MEMORANDUM

TO: District of Columbia Zoning Commission

FROM: Jennifer Steingasser, ^{JS} Deputy Director for Development Review and Historic Preservation

SUBJECT: Final Report for Zoning Commission Case No. 97-16A.
Lowell School Planned Unit Development Application for a Major Modification
1640- Kalmia Road, N.W. and 7775 17th Street N.W. Square 2745F, Lots 815 and 817.

Fig. 2 Proposed Construction and Circulation.

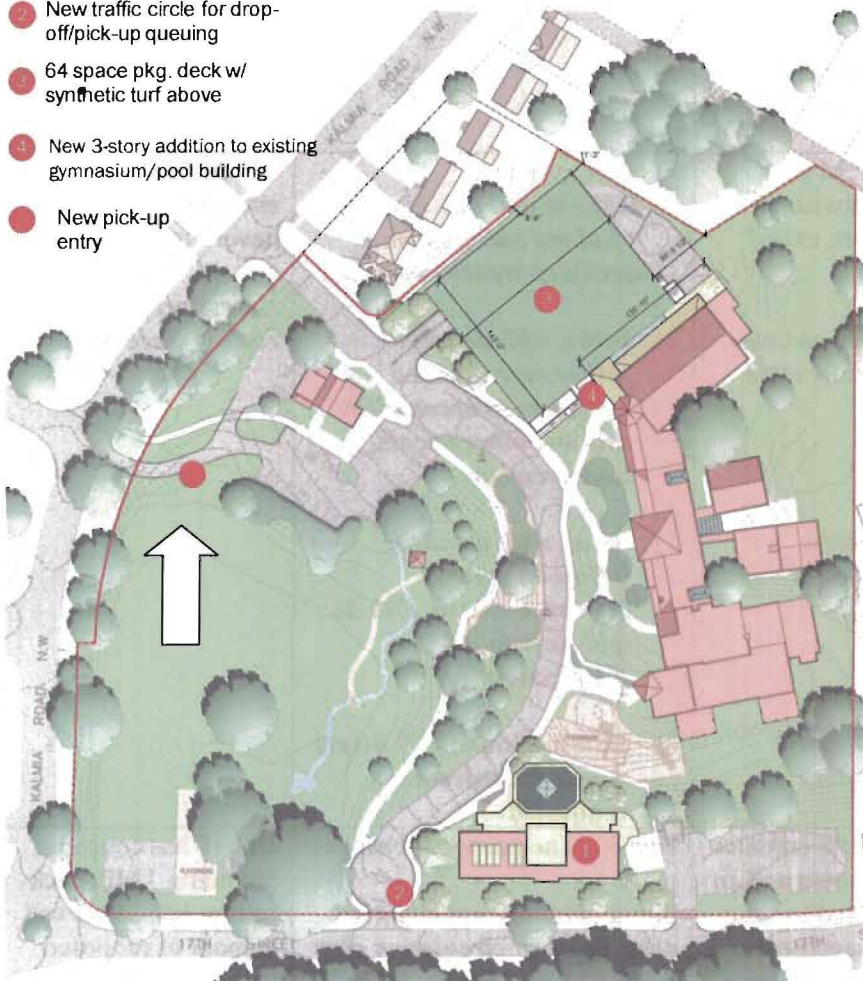
Design: The existing site plan is generally defined by an arc of buildings atop a ridge that descends into a bowl adjacent to Rock Creek Park. OP has suggested to the applicant that minor changes to the angle of the proposed garage may help to reinforce the arc of the buildings on the ridge and improve the views of the main building.
